Tyler Grange Comments 15.07.2020

Application No: V/20/87717

Address: Land West of, Horton Heath

Landscape Officer Comments 15/05/20

Project	Horton Heath
Drawing Title	Site Specific Landscape Character Areas
Scale	Not to Scale
Drawing No.	11705/P23
Date	July 2020
Checked	KL/RP

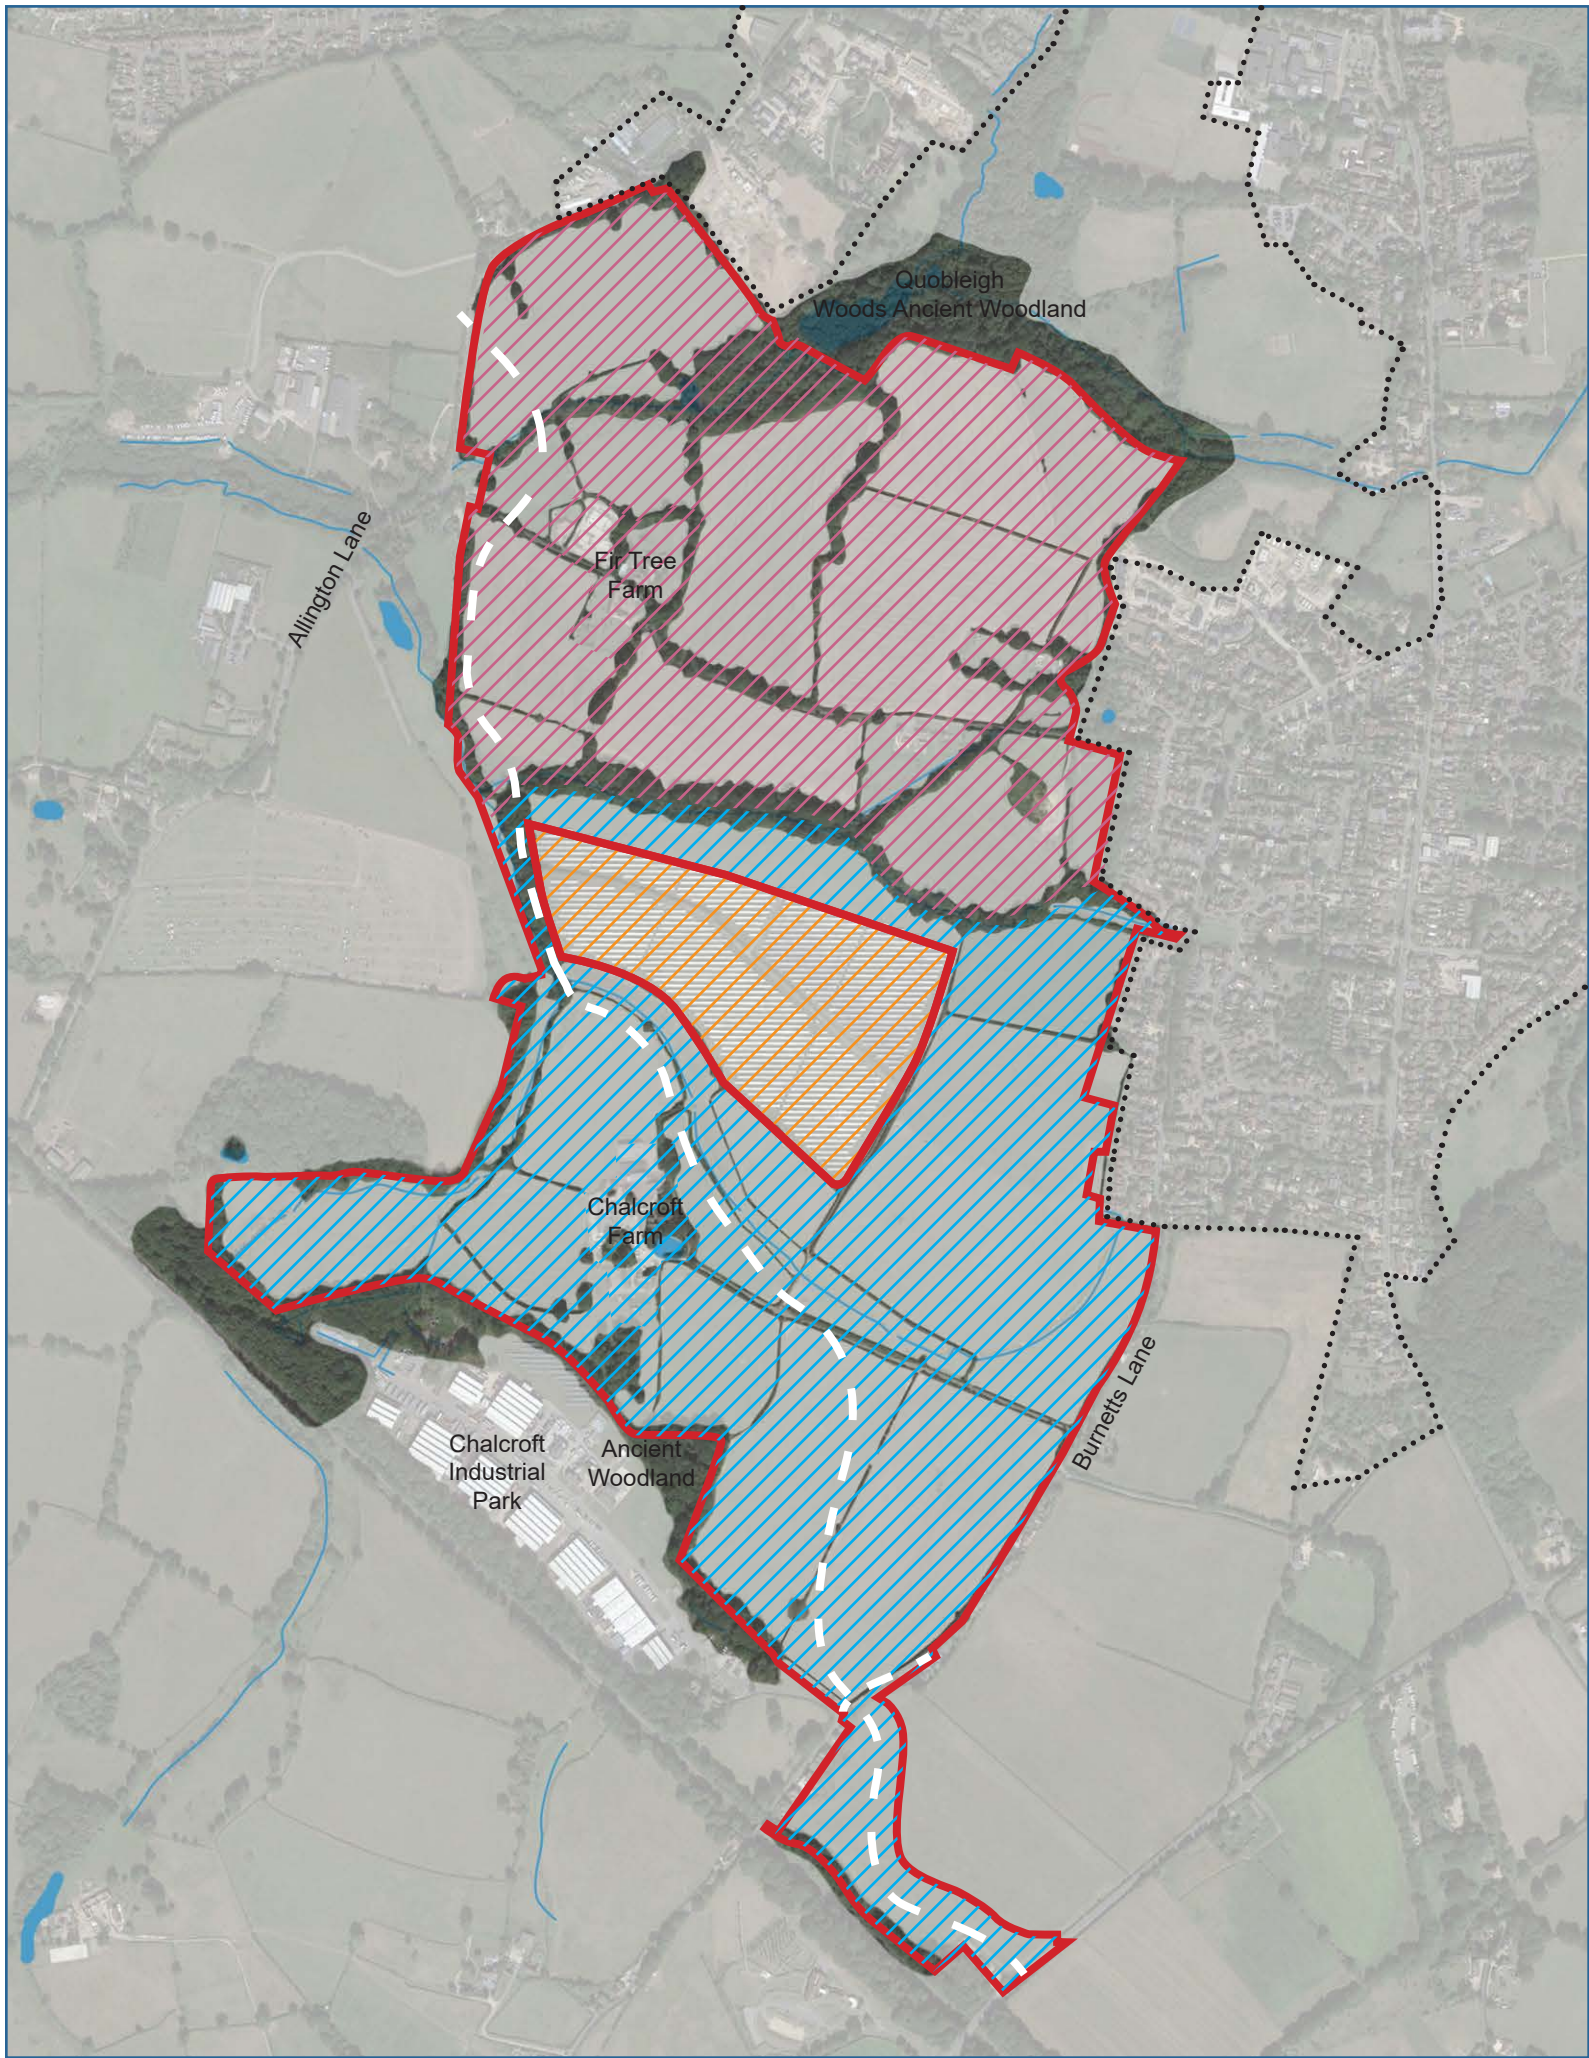
a) Action: As set out in 2b above please add neighbouring LCA's to Landscape Receptors.

b) Discrete landscape elements have been identified as Landscape Receptors. It would be helpful to also look at how this can be framed from a holistic Green Infrastructure perspective. Therefore not only looking at the effects on the individual elements but also packaged as GI ‘typologies’ or systems. For example; a hedge with some mature tree in it and wildflower meadow at its base, or perhaps with a drainage ditch alongside, is a richer feature in landscape terms with a higher intrinsic value than assessing at a hedge in isolation. Some thought should be given to how these can be defined and assessed this way.

Action: Review landscape receptors and provide criteria for GI typologies or systems.

The landscape receptors will be updated to include GI Typologies. The key Landscape Character Areas which will be assessed are identified on Plan **11705/P23**:

Within these key character areas are a number of 'GI Typologies' as identified on Plan **11705/P23**.
